E8363BH85-03A

S E R V I C E N O T E

E8363BH85 PNA Microwave Network Analyzers

Figure 1: A3 Front Panel Interface Board Assy without the Bracket

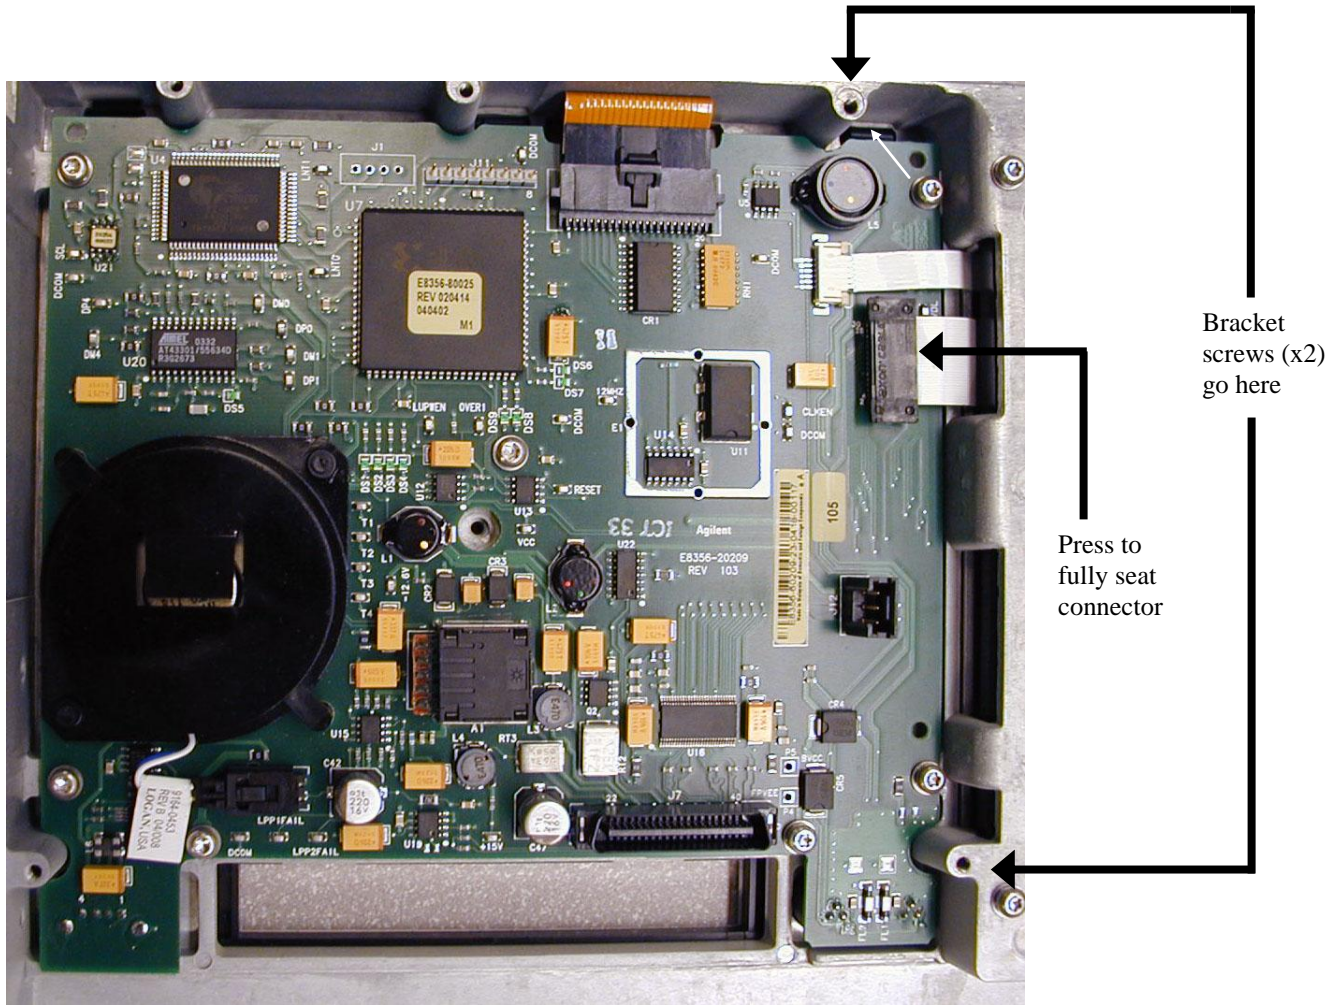
A connector of the ribbon cable (Agilent part number 8120-8409) that joins the front panel display to the front panel interface board can loosen, causing a display failure, unless a new bracket is installed. Because the failure rate has been very low, it is recommended that the bracket be installed only when there is an additional reason to remove the PNA front panel.

1. Refer to Figure 1 in this document:
 - Press down firmly on the ribbon cable's black connector.
 - Locate the two tapped holes for the bracket screws.
2. As shown in Figure 2 in this document, position the bracket so that its holes line-up with the two holes you located in the previous step.
3. Hand-start the two screws, and then torque both to 9 in-lbs.
4. Reinstall the PNA Front Panel by following the Service Guide instructions in the "Replacement Procedure." This is located on the same page as the "Removal Procedure" used previously in step 7.
